Re: **Work Plan Addendum**  
Shell-branded Service Station  
Incident # 98995746  
4411 Foothill Boulevard  
Oakland, California

Proposed Monitoring Well Location and  
Conduit Study Map

FIGURE  
**1**

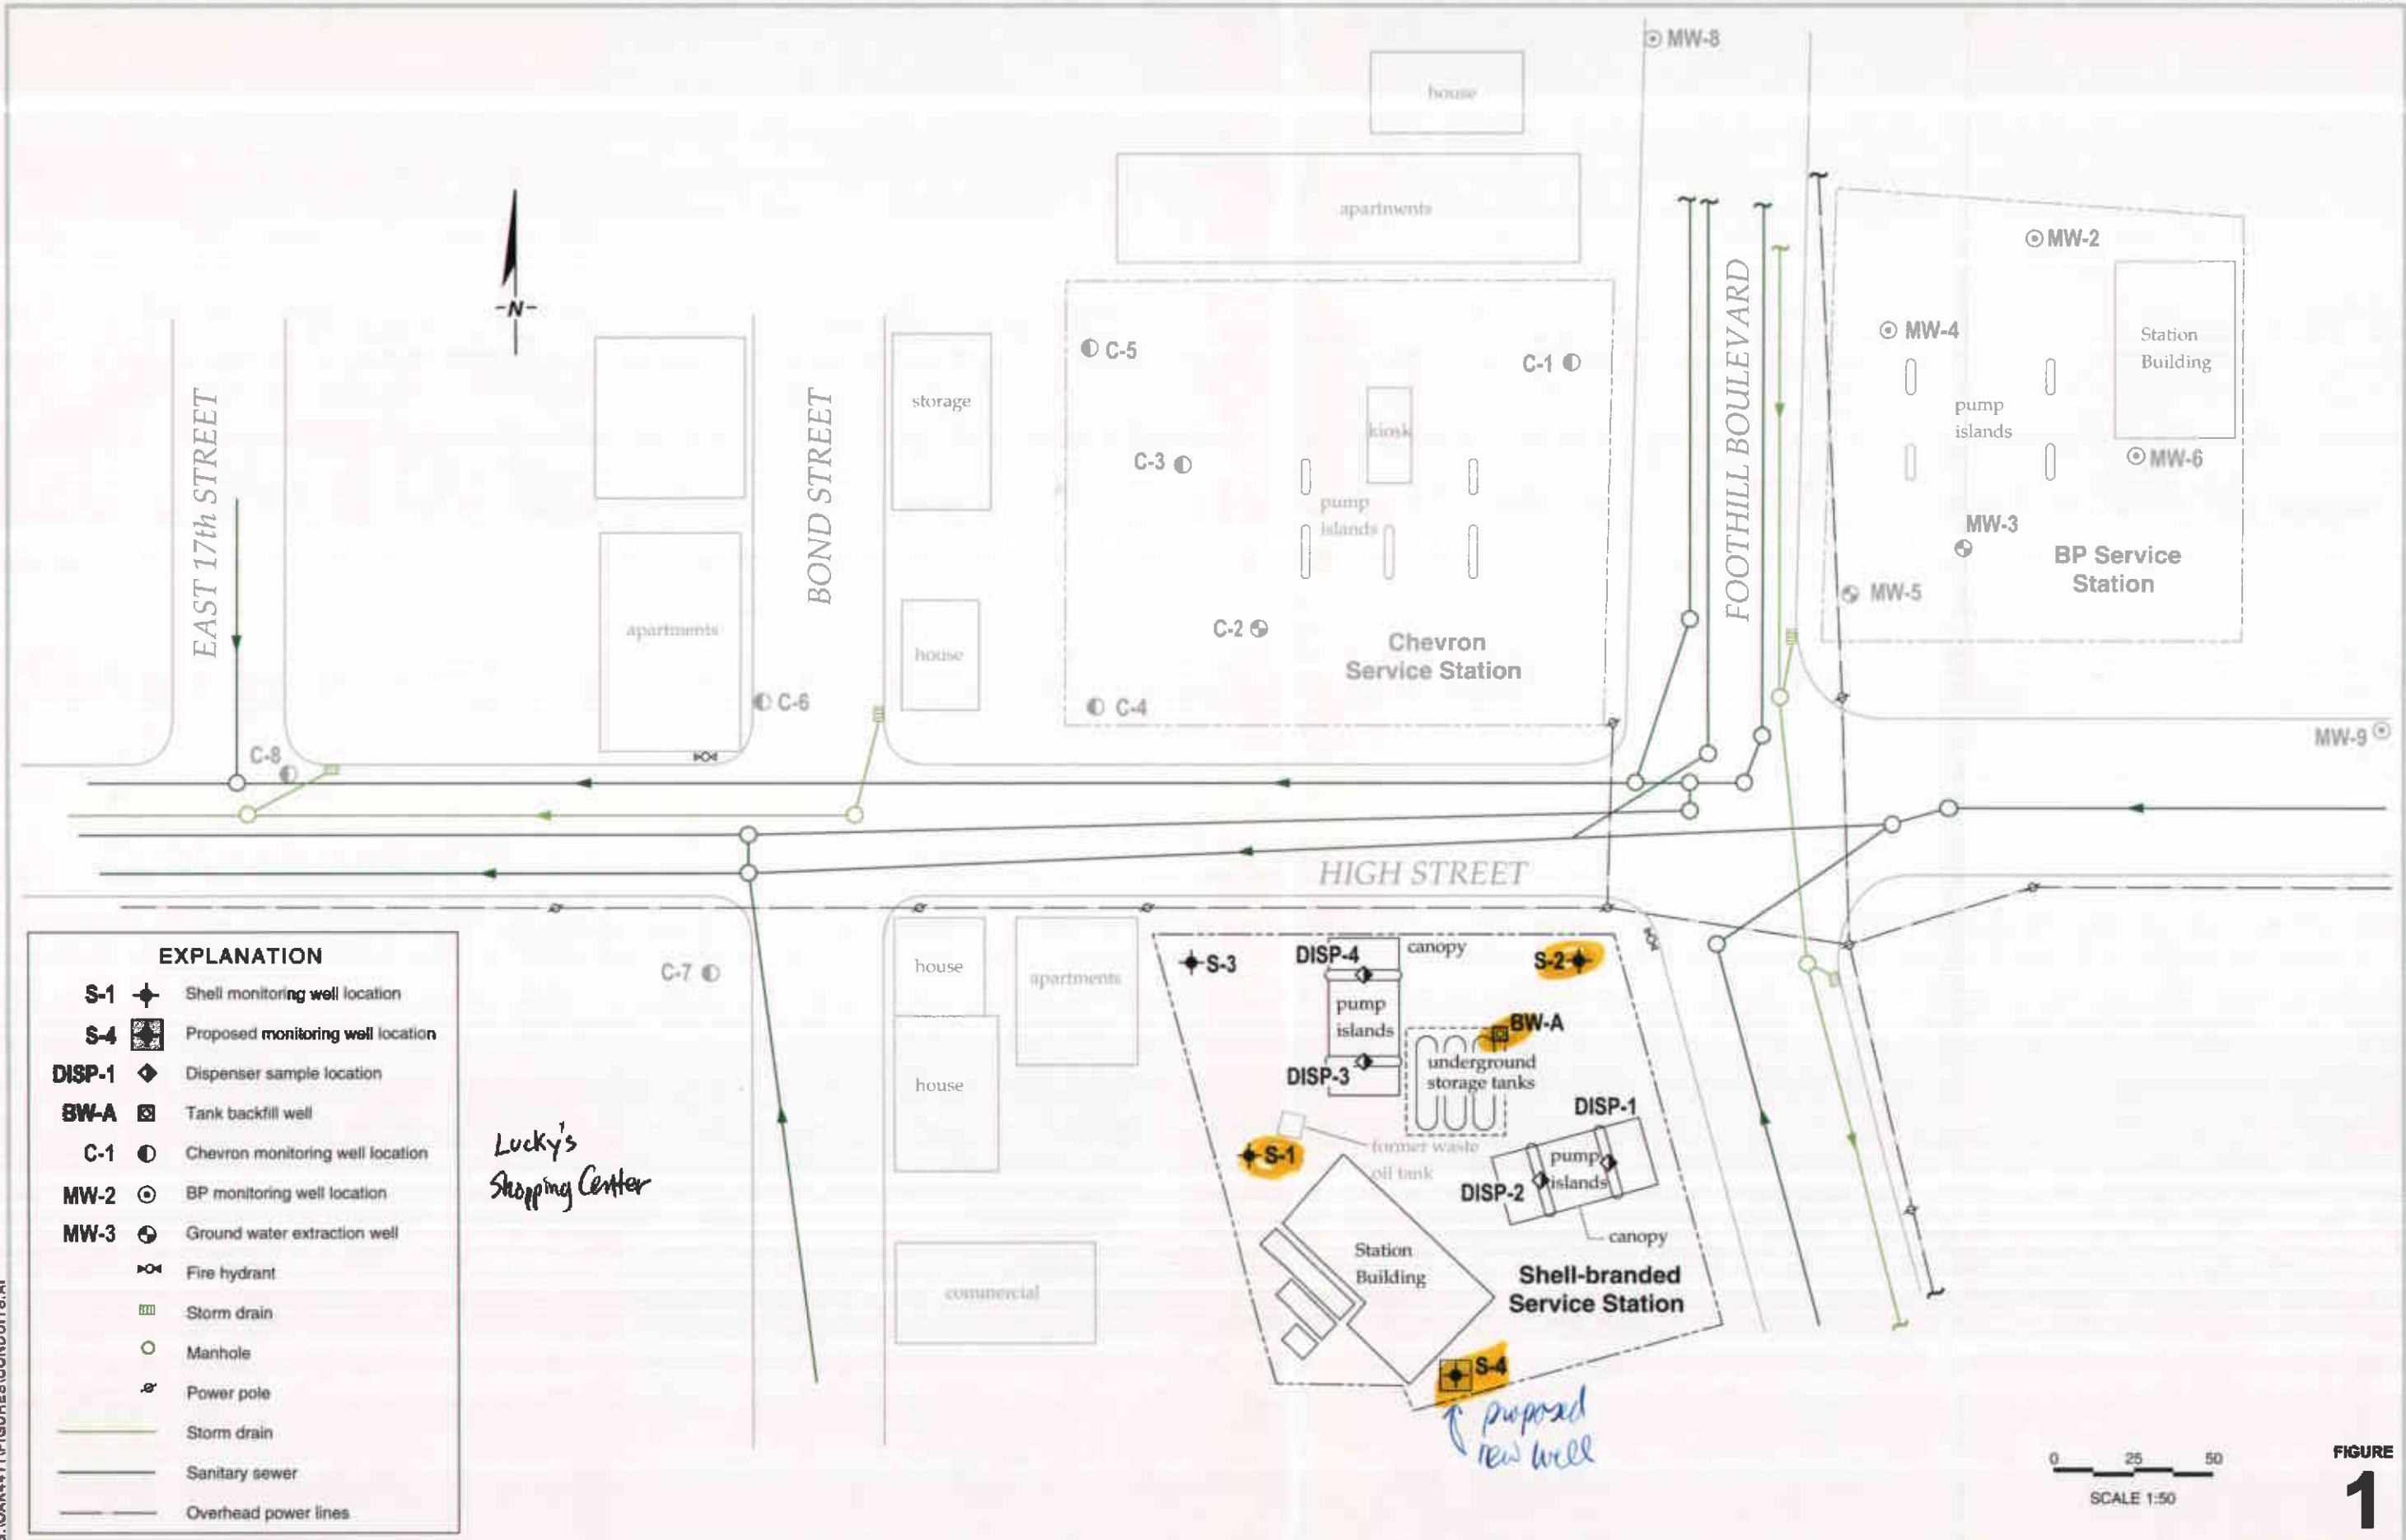
As discussed in our February 1, 1999 phone conversation, Cambria will relocate proposed monitoring well S-4 to the location shown on Figure 1. This location will provide soil and ground water data closer to the station building and is in the direction of historical ground water flow to the southwest. The scope of work for the installation of MW-4, presented in Cambria's January 11, 1999 work plan, remains the same except we will also include collection of soil physical parameters for future risk analysis. Soil samples from the boring will be analyzed for dry bulk density, moisture content, porosity, and fraction organic carbon in addition to total petroleum hydrocarbons as gasoline (TPHg), benzene, toluene, ethylbenzene and xylenes (BTEX) and methyl tertiary butyl ether (MTBE).
